Technical Note

Project No: ITB16357
Project Title: Land South of A259, Angmering
Title: Additional Information – A/169/21
Ref: DS/ITB16357-008
Date: 1 October 2021

TITLE:		ACCESS ARRANGMENT		DRAWN:	JD	CHECKED:	DS	APPROVED:	DS
PROJECT:		CLIENT:		PROJECT No:	ITB16357	SCALE @ A3:	1:1000	DATE:	08.07.21
LAND SOUTH OF A259, ANGMERING		REDROW		DRAWING No:				ITB16357-GA-008	
								REV:	
								A

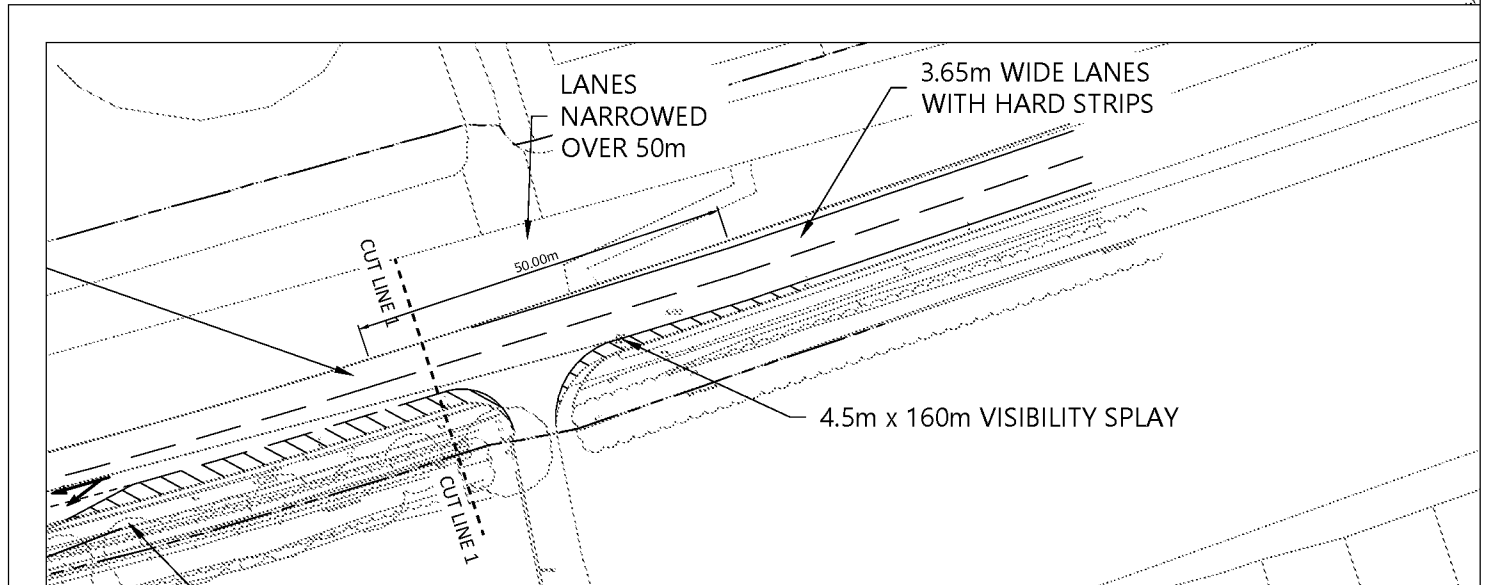
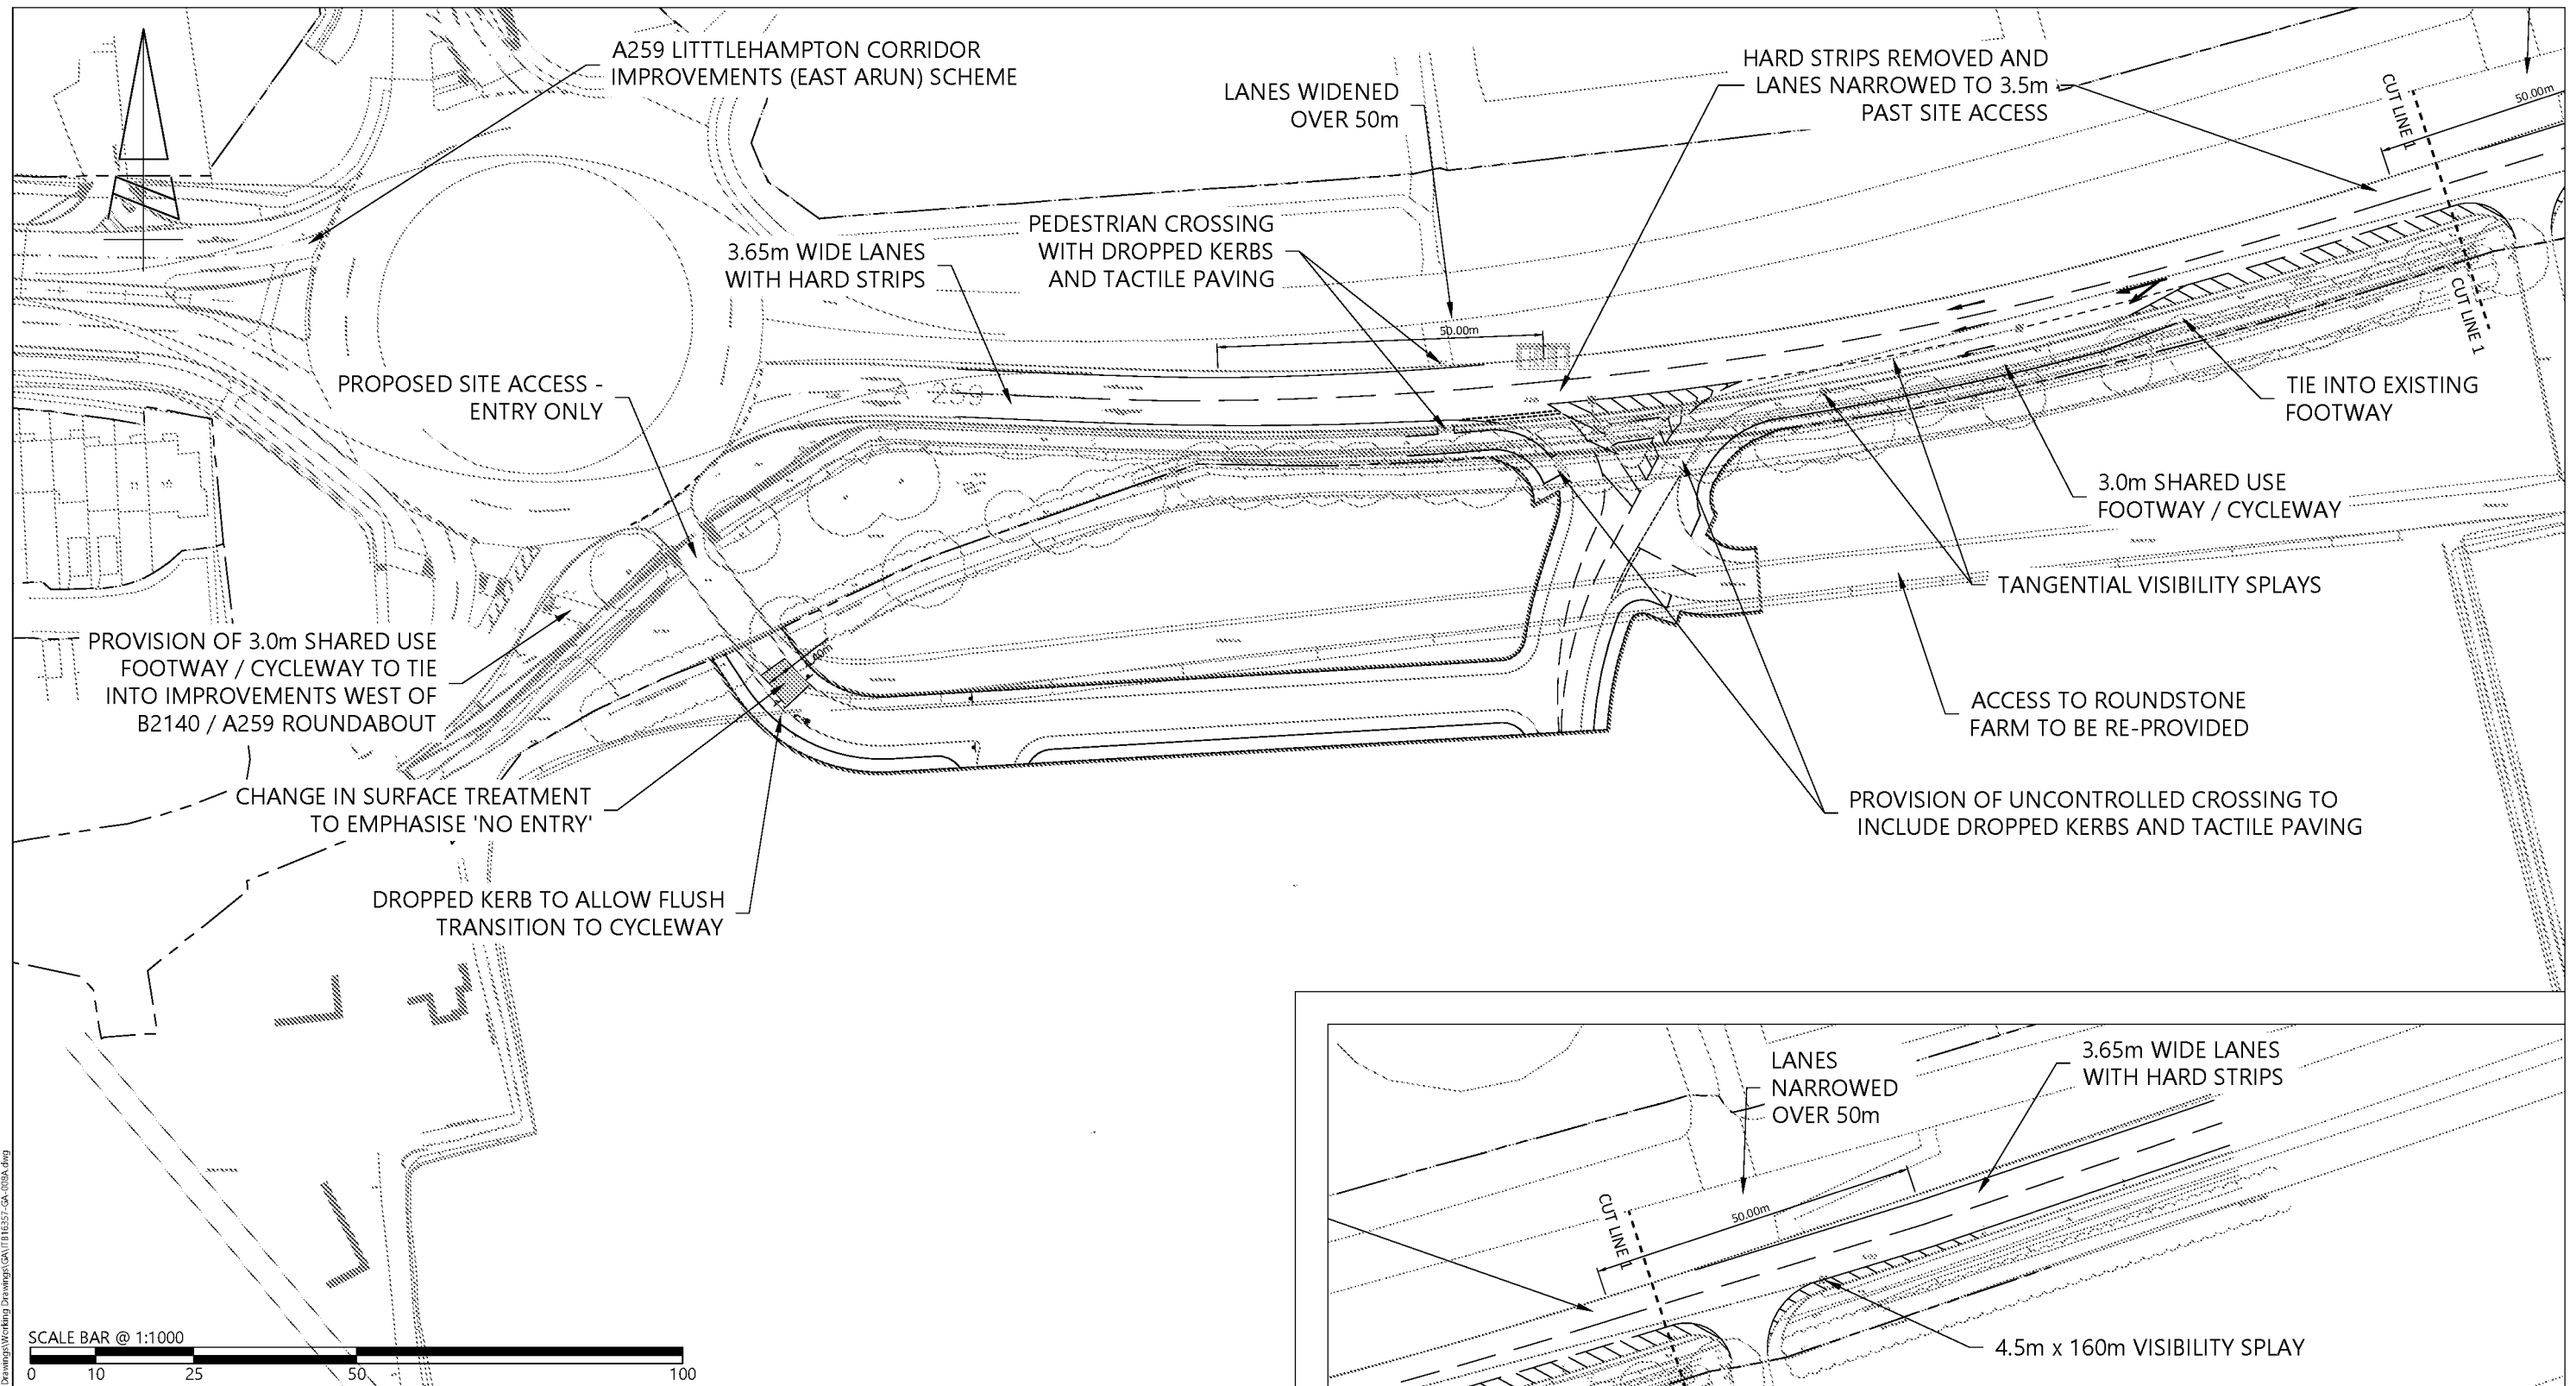
1.1.2 West Sussex County Council (WSCC), in their capacity as the local highway authority, has responded to the application requesting further information as summarised below:

- Design Audit identifying standards used in the design and any departures;
- Removal of the bus stop from the A259; and
- Retention of the existing left in, left out access.

1.2.1 The design of the site access arrangement has been modified in order to remove the existing bus stop located on the live nearside lane of the A259 carriageway, as requested in the WSCC response. The amendment is shown in **Drawing ITB16357-GA-008 Rev A**.

A	01.10.21	MC	BUS STOP REMOVED	DS	DS
REV	DATE	BY	DESCRIPTION	CHK	APP
STATUS: FOR INFORMATION
